Subject: Contract DE-AC05-91OR21950
MISSOURI - EPA DRAFT REMEDIAL INVESTIGATION (RI)
ADDENDUM REPORT FOR THE ST. LOUIS SITE, APRIL, 1993

Formerly Utilized Sites Remedial Action Program (FUSRAP)

for the St. Louis Site, Missouri

ATTACHMENT 2
1985 GEOTECHNICAL DATA

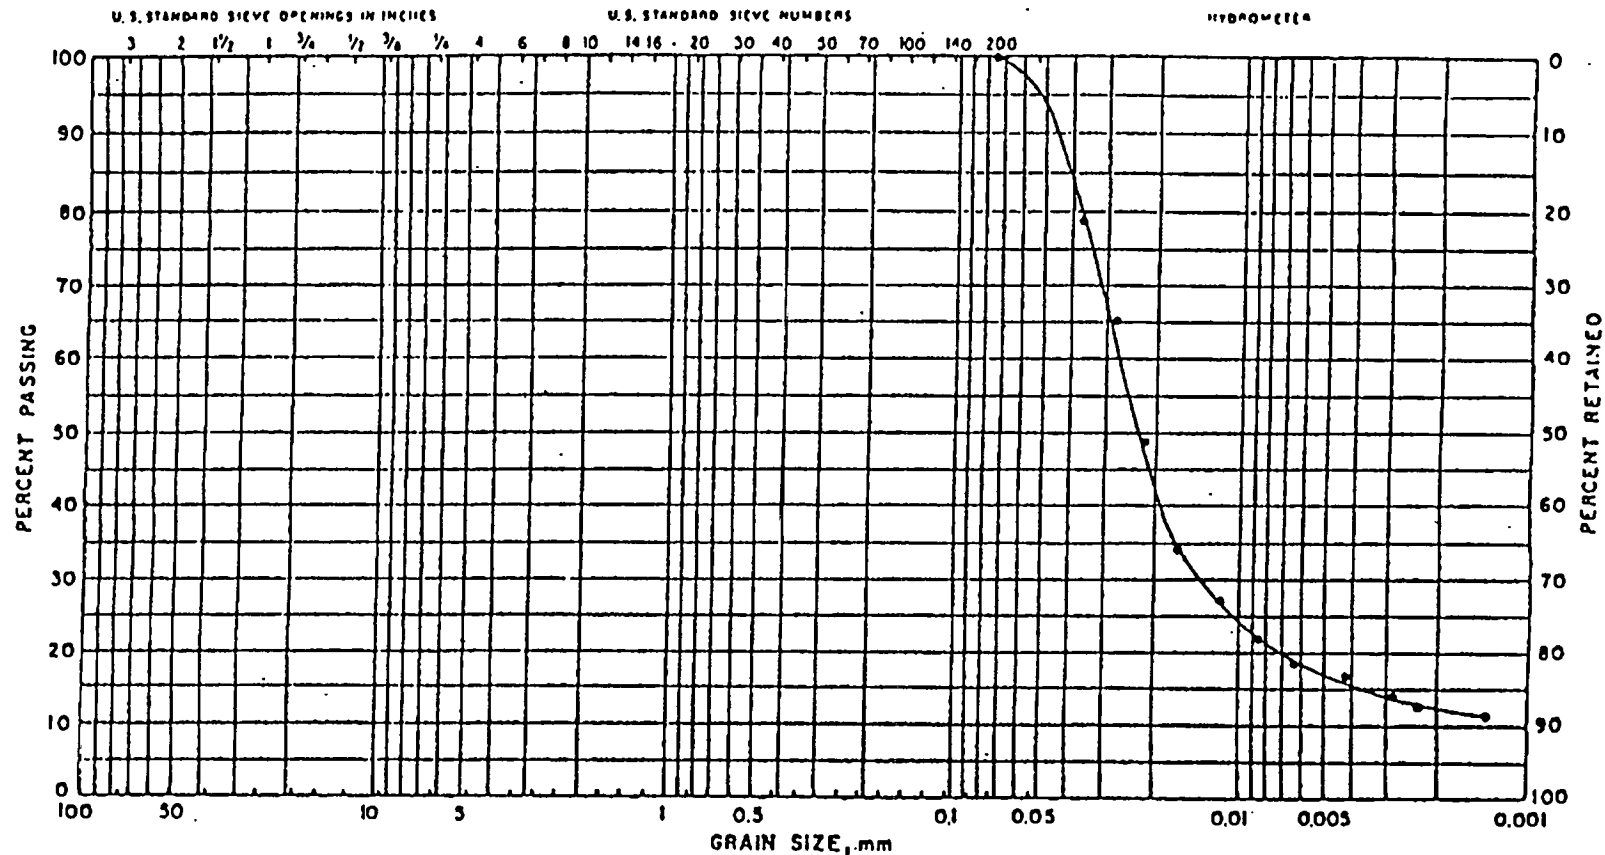
2. In the EPA letter on the RI Report (January 1992), an inquiry was made on the collection of other types of data (referred to in a 1985 well inspection report) that were not included in the RI Report (e.g., boil-down tests and sieve analysis data). Geotechnical data has historically been reported in the RI, Work Plan, and specific characterization reports. The 1985 well inspection report inquired about was designed to provide well installation data and not sample analysis results. Permeabilities reported in the 1985 report are summarized in Appendix D Table D of the RI Report. No draw down tests were conducted during the investigation. Grain size distributions, inadvertently omitted from the RI Report, are provided as Attachments 1, 2 and 3 to this transmittal letter. These three curves actually represent four wells. HISS 10 and HISS 12 grain size distributions are provided in Attachments 1 and 2 respectively. Samples from HISS 15 and HISS 11 were combined for the Attachment 3 curve.
